Environment Victoria submission to Viva Gas Terminal Supplementary EES

Full submission lodged 31 October 2024 via email to Planning.Panels@transport.vic.gov.au

Review of marine ecology and dredging aspects of Viva Supplementary EES.

No details on water volume in experiment estimating chlorine plumes

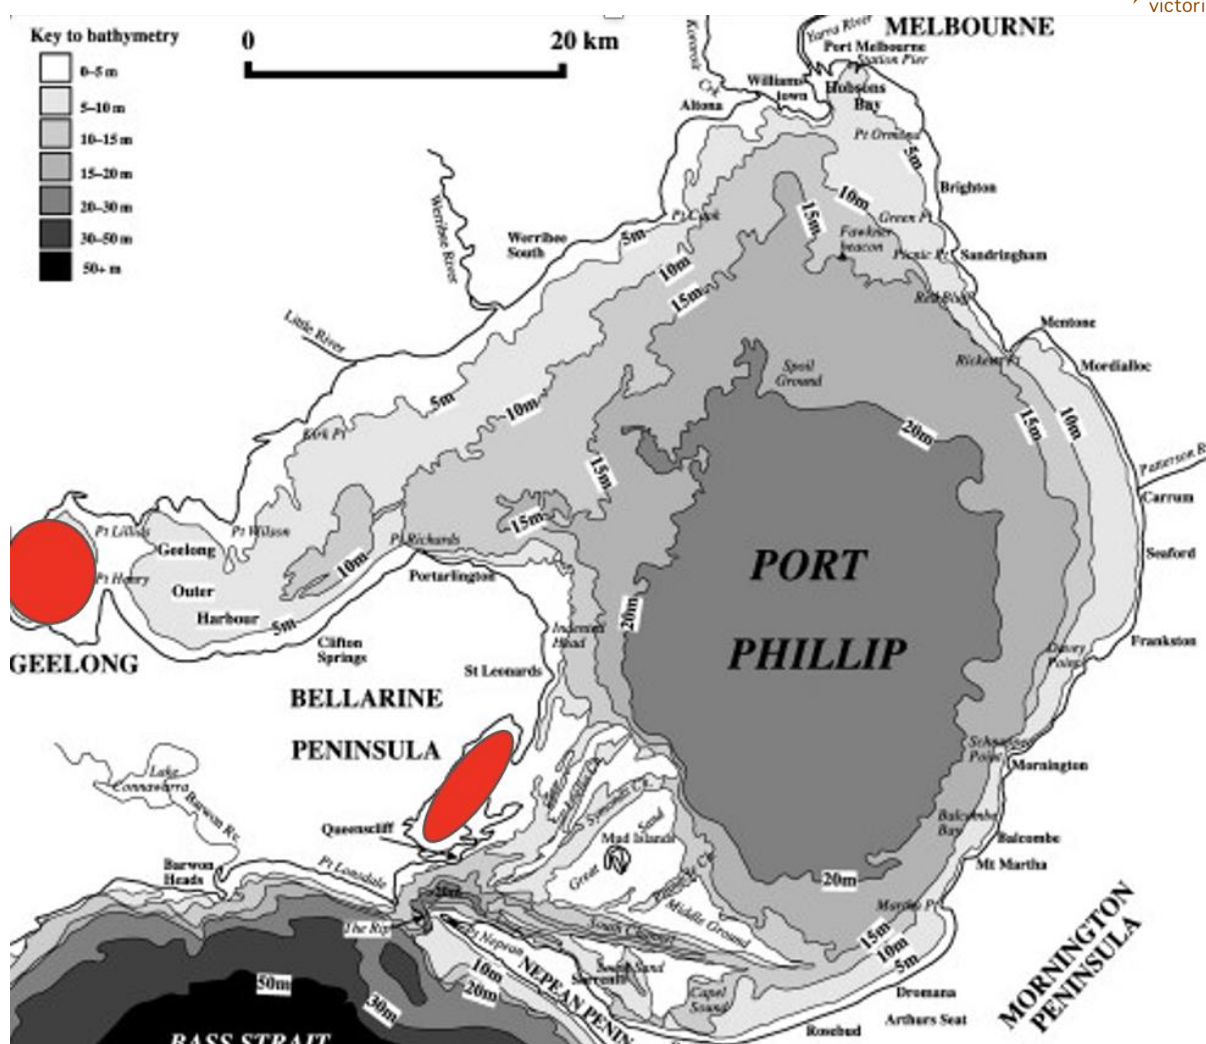
The Technical Report does not specify the volume of water in the experimental tank used to estimate rate of loss of chlorine.¹ Since the rate of loss is likely dependent on the surface-volume ratio, it is difficult to independently verify this study without the missing information.

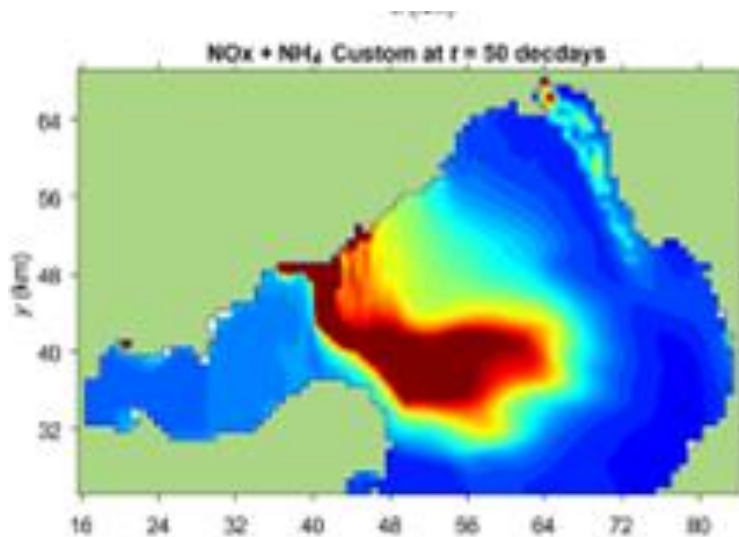
The ecology of Corio Bay differs from broader Port Phillip Bay. In Corio Bay and Swan Bay nitrogen is mostly sourced from microbes associated with seagrass roots, and most of this nitrogen is retained because seagrass leaves stay within the enclosed embayment. The following map shows how Corio Bay (red circle) and Swan Bay (red oval) are sheltered from broader Port Phillip Bay.

In Port Phillip Bay, by contrast, the Yarra River and the Western Treatment Plant provide a large external source of nitrogen, and seagrass leaves are mostly not retained. The following illustrates the extent of this nitrogen plume into the Bay.

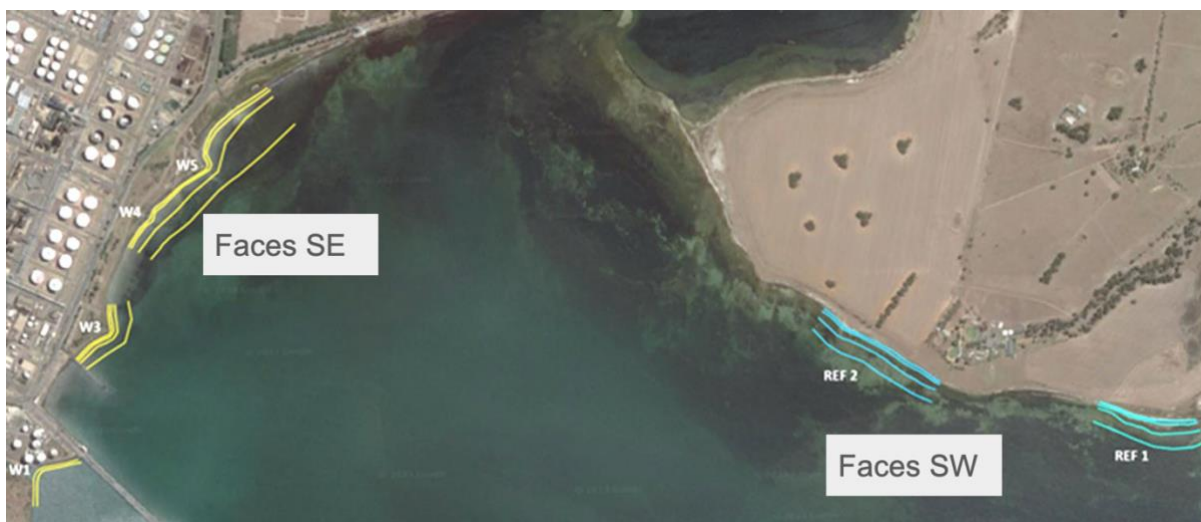
This makes seagrasses within the plume of the Western Treatment Plant an inappropriate comparison with seagrasses in Corio Bay. And yet Technical Report A Figure 3-6 includes plots for seagrasses at Bellarine Bank and St Leonards, which are at the north and north-eastern sections of the Bellarine peninsula, likely affected by the plume from the Western Treatment Plant. These plots are used to show a significant year-to-year variation in seagrass cover, which the SEES argues would also apply to Corio Bay – but the comparison is not appropriate, given the very different sources of nitrogen, a limiting nutrient for growth.

It's worth noting that Stantec's peer review of this chapter also raised issues with this figure as being 'of questionable relevance as it is nowhere near the area of interest'.² The comment was closed with no change made.

This assertion that Corio Bay and Bellarine Bank/St Leonards are directly comparable is later relied upon to dismiss changes in seagrass cover near refinery outfall W5 (Figure 3-19) but the evidence presented does not support this claim.
